STERLING RANCH DEVELOPMENT BRIARGATE BOULEVARD BRIDGE CONSTRUCTION DRAWINGS

EL PASO COUNTY, COLORADO

Kiowa Project No. 19032
5/2/2022

BRIDGE PLAN
1"=10'

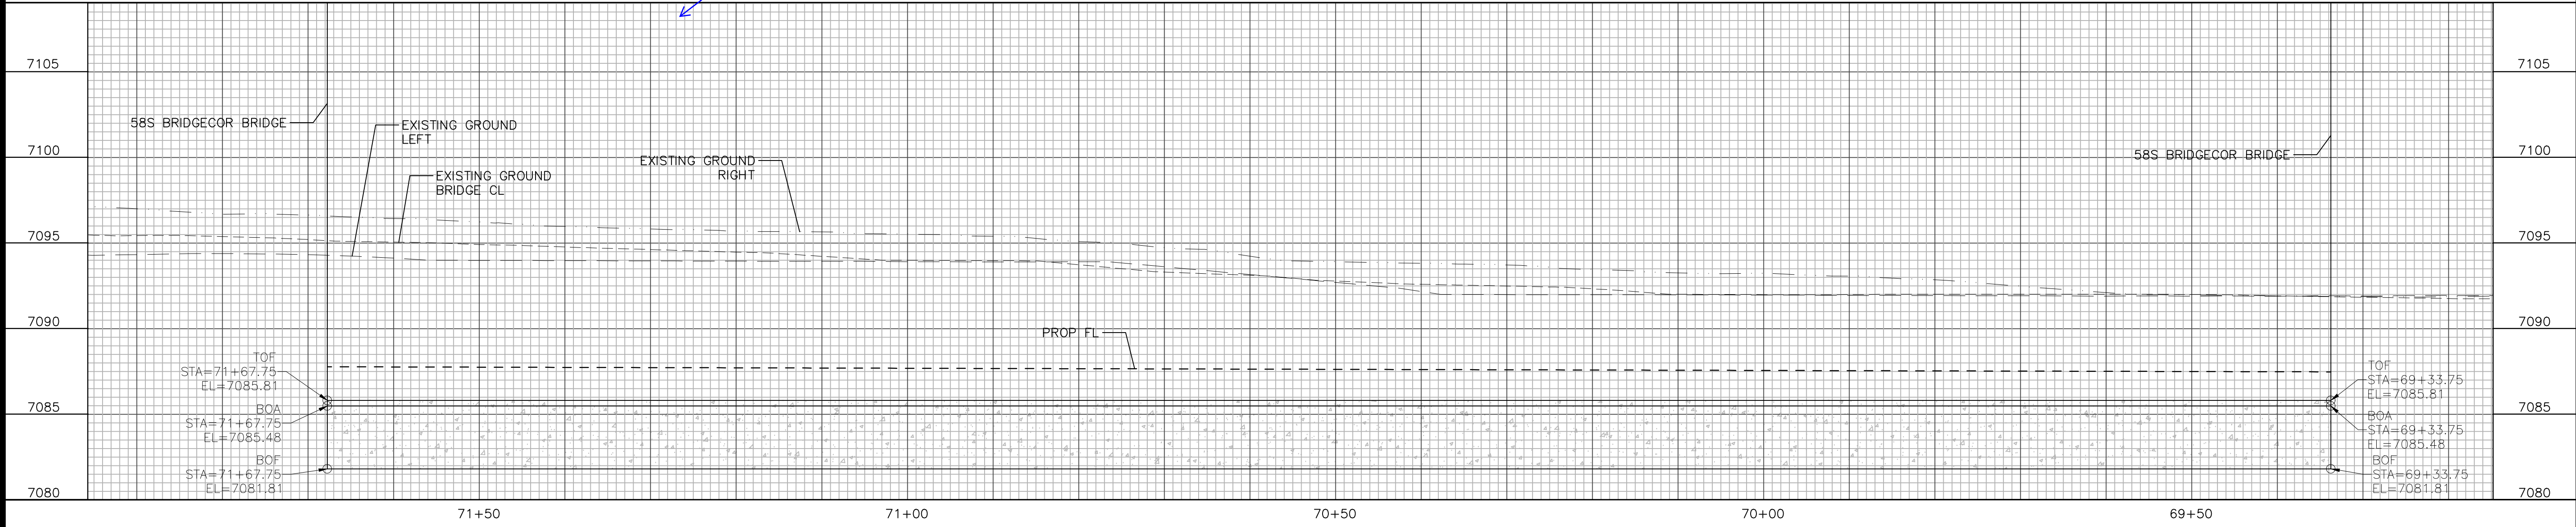
Please lighten the grid
